Access Compliance Report

Public Rights-of-Way

(Curb Ramps)

Intersection ID: 2826	Main Street: BELL'S_MILL_DR	Cross Street: TAYMOUTH_LN	Location: S
ADA ID: D69024BDFB12	Ramp Type: PerpDiag	Initial Pass/Fail: Fail	Overall Compliance: No
Codes/Mitigation Info/Possible Solution		Field Measurements/Component Compliance	
Severity Score: 8.75

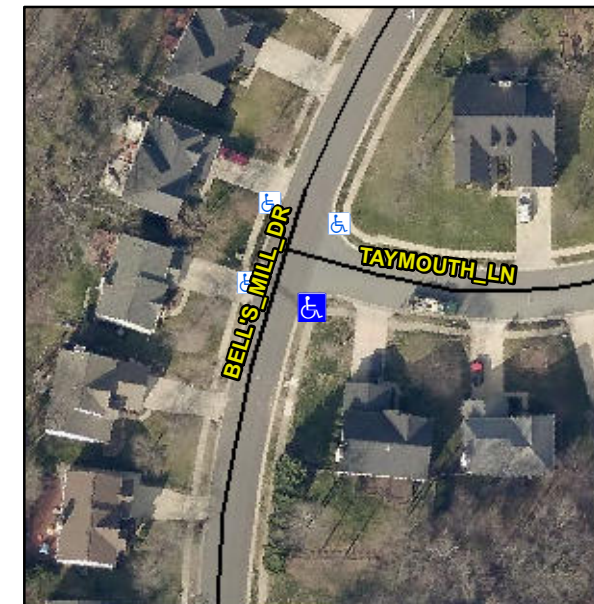
Remove & Replace Curb Ramp With Two New Directional Ramps or Equivalent.

R304.5.1
